Service information

Reference no.: SDA_92093

Water leakage

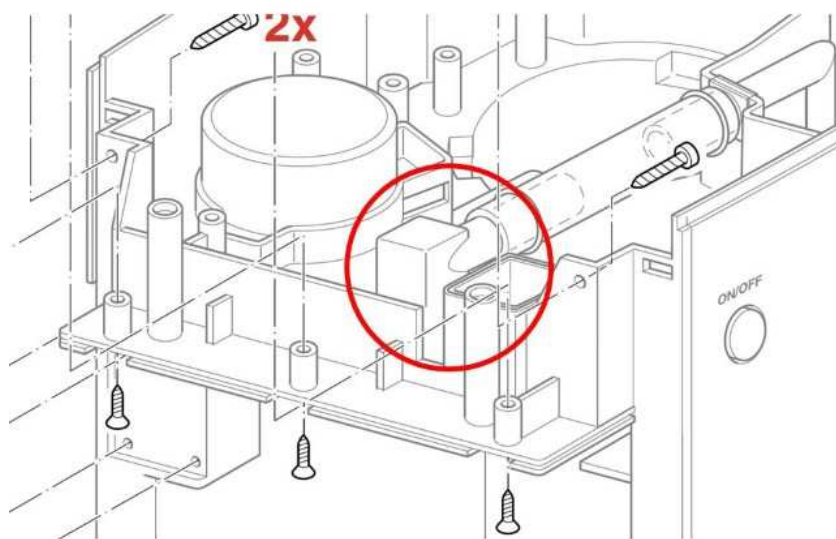
From field quality analysis we have observed leakages in the appliance which can be solved, preventing Non Standard Exchanges.

Remove the top cover from the appliance, underneath you can see the "shower head" which sprays the hot water into the coffee-filter.

...y seal the steam vent joint between the appliances frame and top cover, next to the shower head.) When you discover that the screws have been overturned / overtightened, it may help to fit slightly larger screws. It has been the case that the screw torque was not always well under control in the production line.

(Tip: exchange the overturned screw by a screw from the base plate (under the rubber feet), this screw is slightly longer, the screw from the showerhead also fits in the base plate.)
